DAVID PLUMMER & ASSOCIATES

Re: Mediterranean Village Review - #14153
Traffic Impact Study, Parking Analysis & Valet Operations Analysis

David Plummer and Associates (DPA) have completed several reviews of the Traffic Impact Analysis, Shared Parking Analysis, Parking Garage, and Valet Operation Analysis conducted for the proposed Mediterranean Village project. A summary of these components is below.

HOTEL DROP-OFF - OPTION #3 “STAFF RECOMMENDATION”

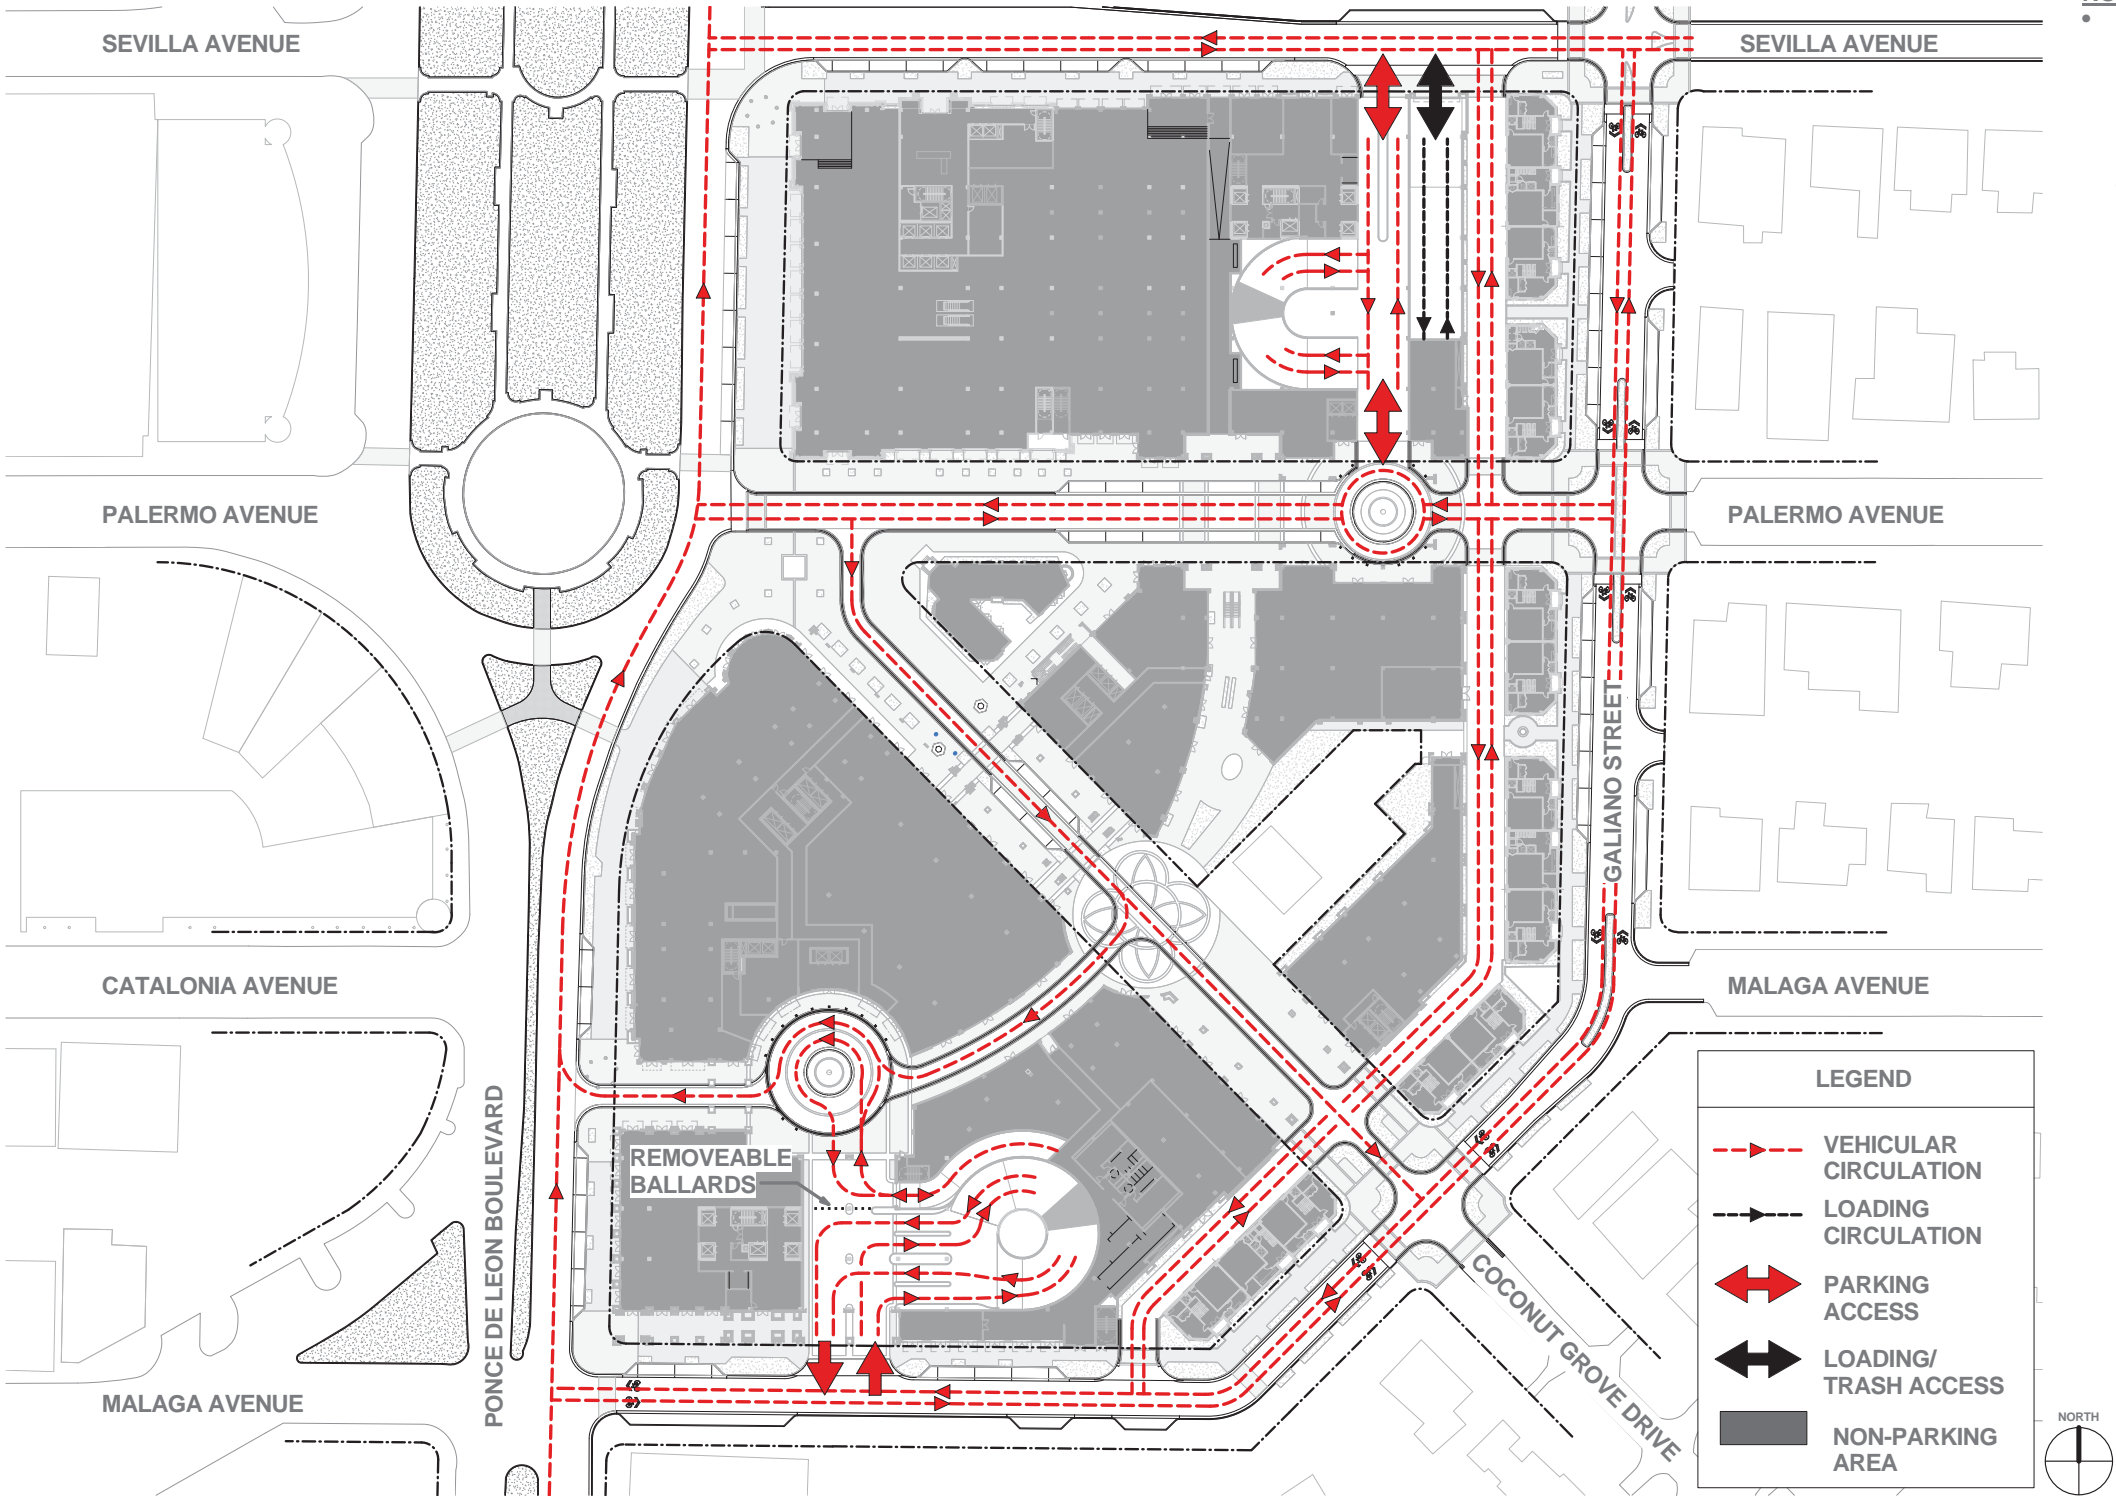
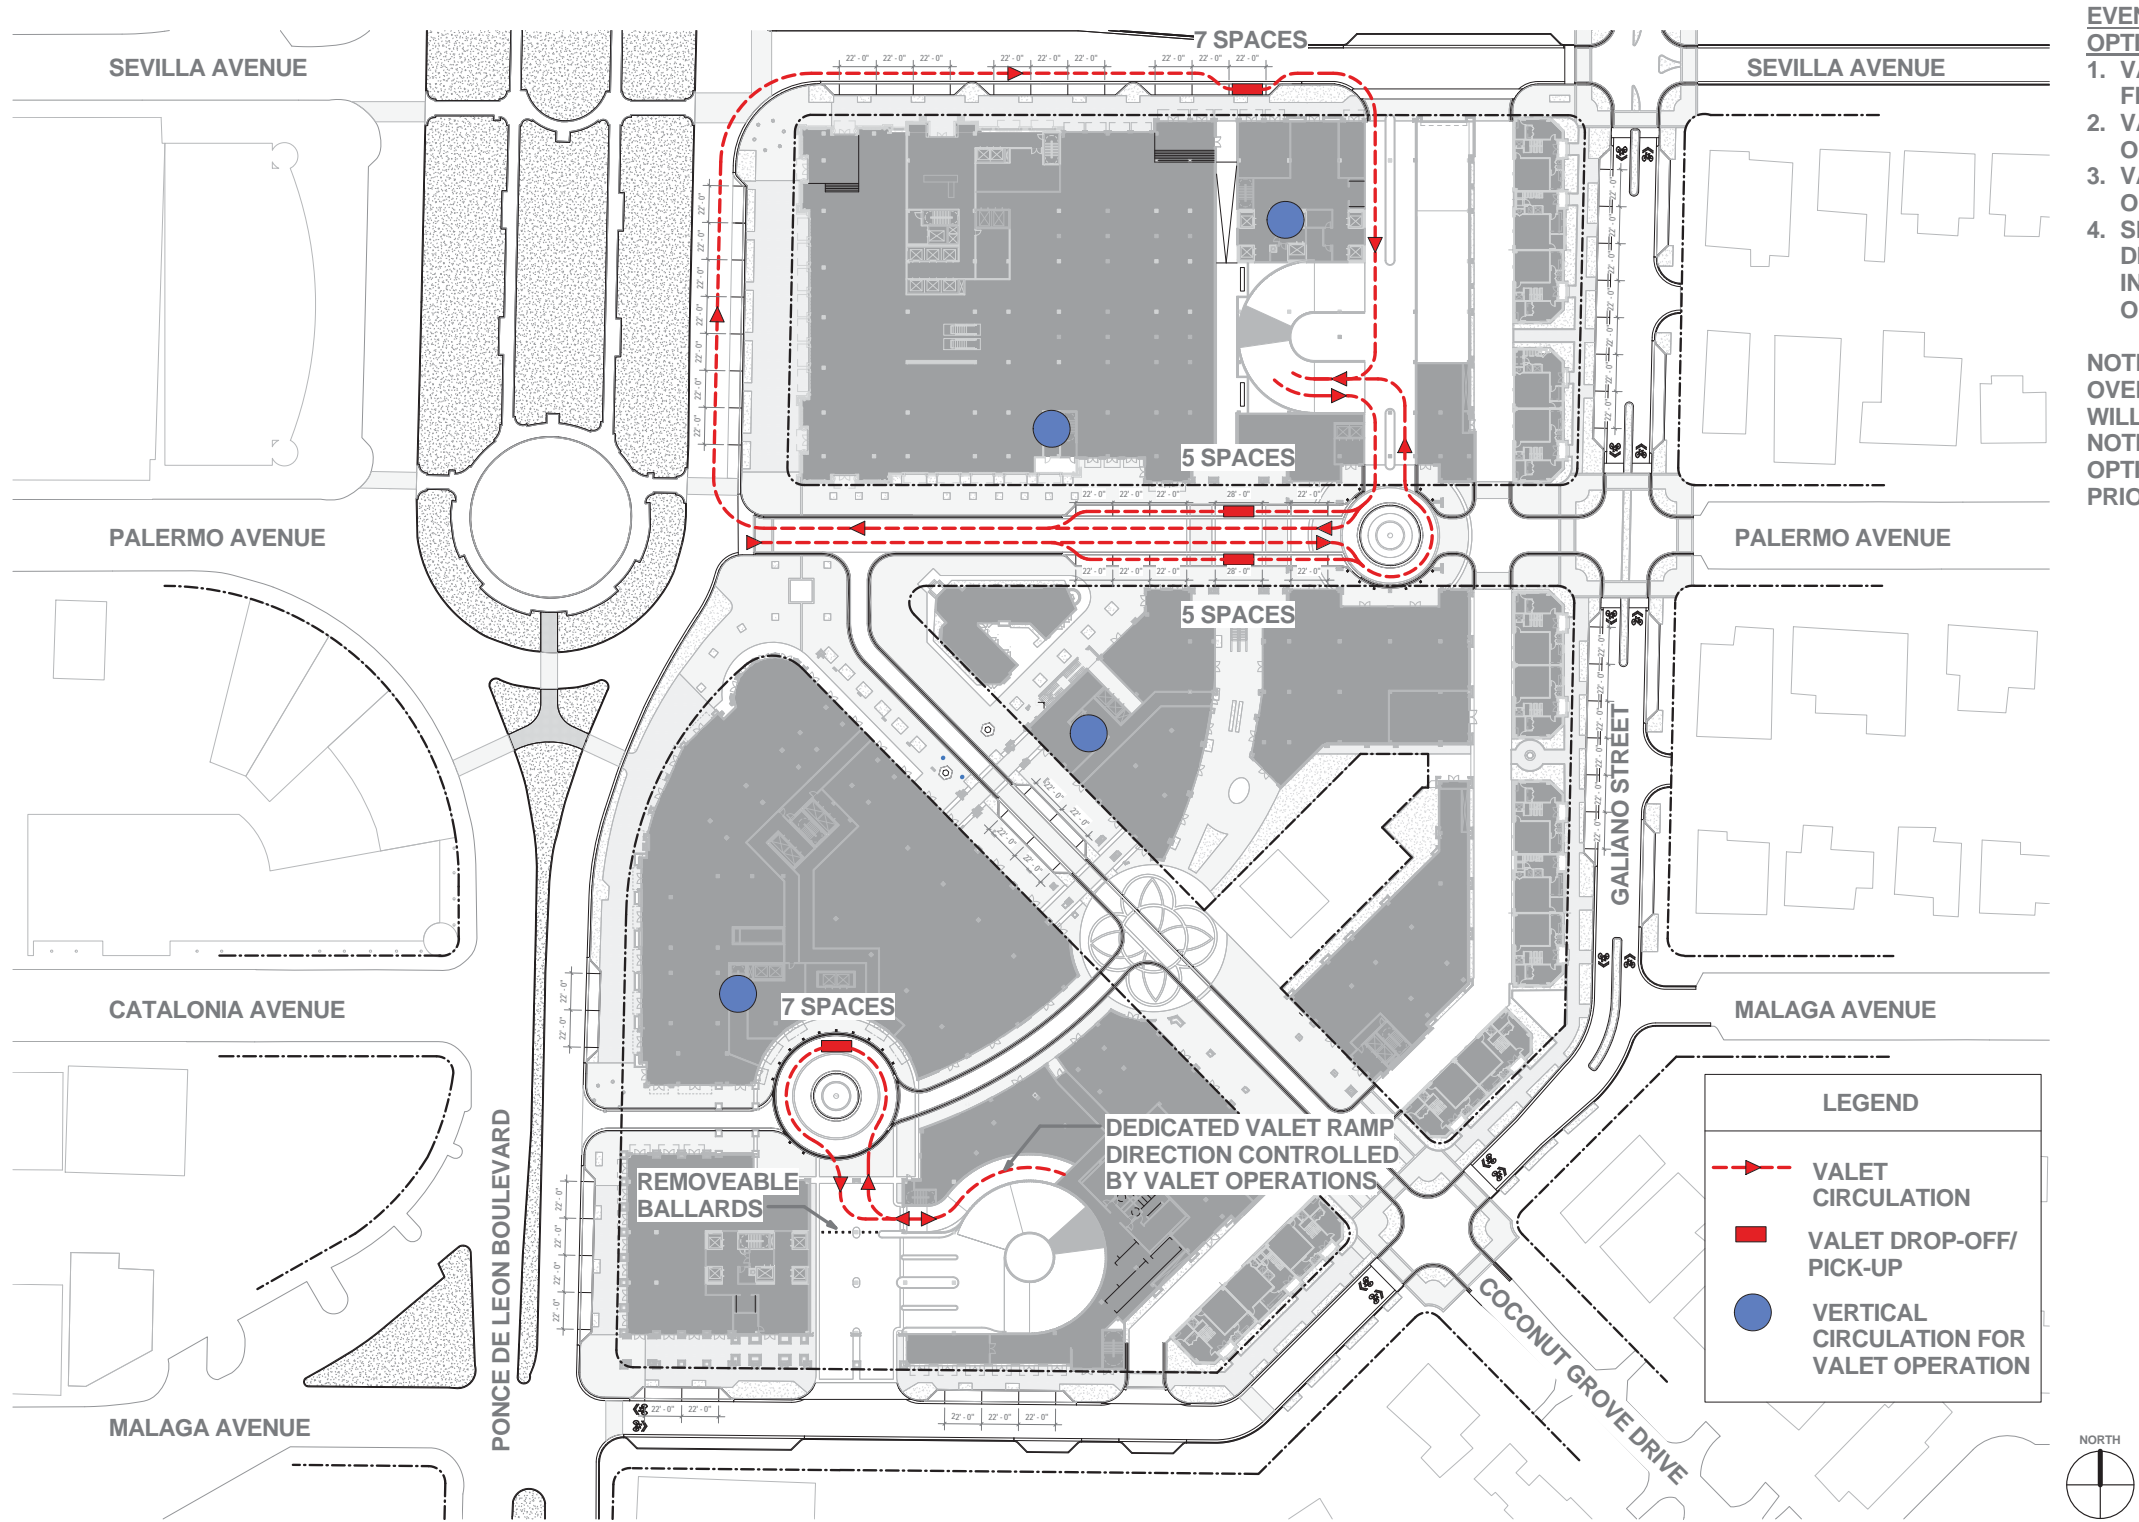
During first reading, the project included direct access to the hotel from Ponce. This access plan for the hotel was acceptable. The project has since changed to address comments from the Commission. Of the newly proposed options, Option 3 is an acceptable alternative and preferable to Option 2 provided that the following conditions are included: 1) the hotel valet ramps will be completely segregated from the Malaga driveway ramping system and no traffic from Malaga would be allowed to access the hotel's porte cochere, and 2) two one-way ramps (similar to the Ponce alternative) or a two-way, two-lane ramp for hotel valet use only is provided. See attachments for hotel access options.
